**Assessment of and Protection Recommendations for 13 Regulated Trees
At And Adjacent To**

**116 Vallecitos
Los Gatos, California**

Prepared for:
Mr. Ryan Safty, Associate Planner
Town of Los Gatos Community Development Department
110 E. Main Street
Los Gatos, CA 95030

Report by CTA
12/16/2025

21

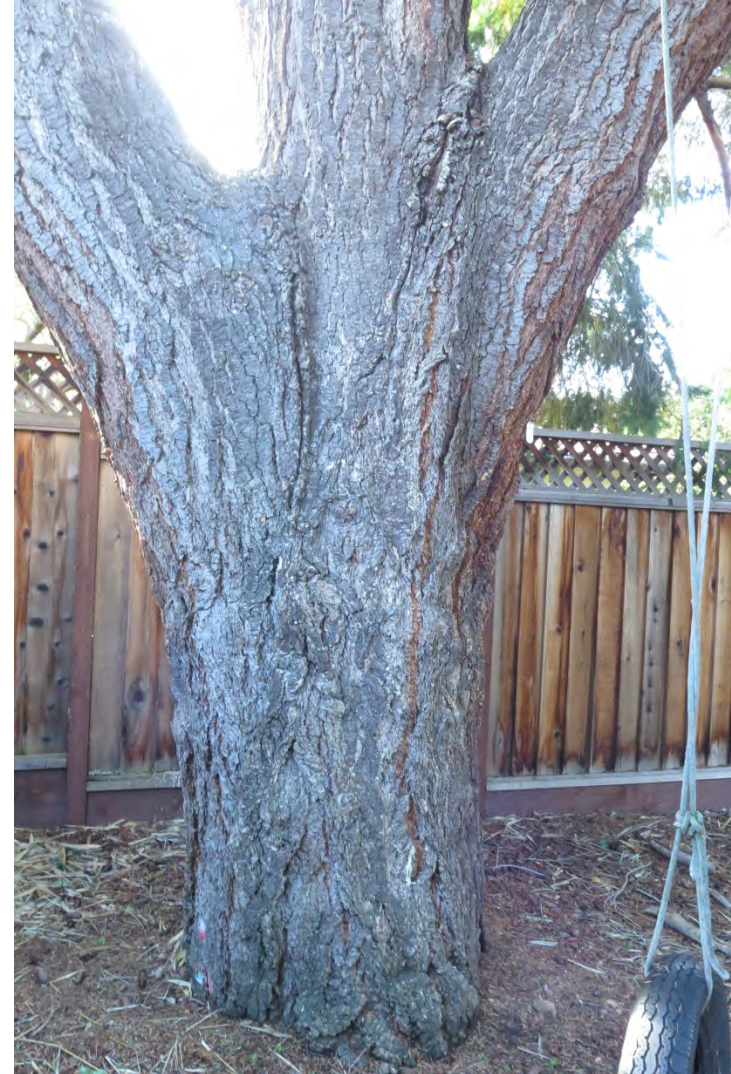
- Tree 21 may experience severe negative impacts if the proposed new gas line trenching and proposed new property line wall are built out at the current proposed locations shown on the applicant’s site plan sheet 4 of 19.

The CTA suggests either pushing these two items farther offset from the mainstem of tree 21, such as 6 feet offset for gas line and 10 feet offset for wall work.

If relocation of the gas line and/or wall position is/are not possible, then “trenchless technology” could be utilized to safely bore the gas line underneath the root system of the tree at depth such as at 3 to 4 feet depth, and a “floating over-grade beam suspended on vertical piers” could be used to build the proposed new wall above the lateral woody root system of the tree.

- **GAS PIPE:** Adjust the gas pipe alignment to at least 6 feet offset from trunk edge of street tree #21, or use trenchless technology to bore the gas pipe underneath the tree’s root system at depth.
- **PERIMETER WALL:** Adjust the location of the property line wall near street tree #21 such that it is 10 feet offset from the trunk edge, or alternatively, build the wall as a floating system that uses an over-surface-grade beam suspended on vertical piers, such that the work is completely above existing soil surface grade elevation, thereby allowing the tree #21 lateral woody root system to be preserved in the area south of the tree.

28

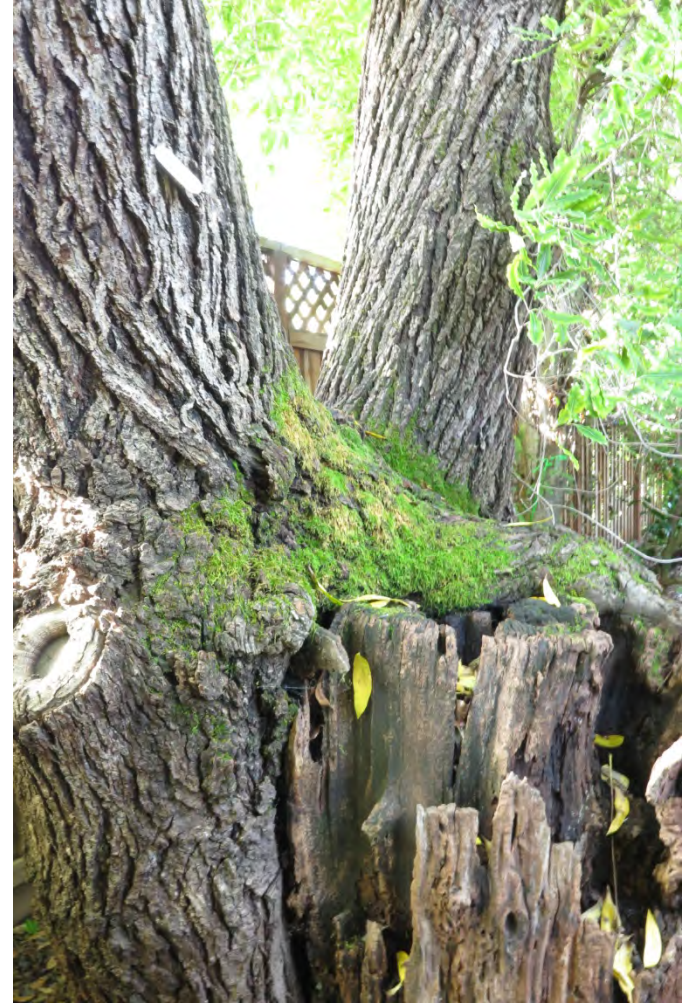
- Tree 28 is a very large specimen of native Northern California black walnut with very extensive wood tissue decay progression in the lower mainstem area where a third mainstem was removed at 4 feet elevation in the past. The tree has been extensively pruned by PG&E to clear the overhead high voltage electrical wire right of way. The remaining remnant tree has a compromised structural root system with visible decay in the lower trunk, and a canopy that is lopsided northward toward the proposed residence. The CTA recommends removal of this tree for safety purposes.

Wood tissue decay of a very advanced degree.

Tree 28 remove for safety, as a “high” risk no fee/no replacement tree per code.

Tree 28, the 4th removal of 4 total tree specimens to be removed, is suggested by the CTA to be removed as a “no removal permit fee / no mitigation planting” removal, per Town Code 29.10.0985, for safety purposes. The tree is deemed a high risk tree specimen in terms of risk of tree or tree part failure and impact with persons or property, causing significant damage.
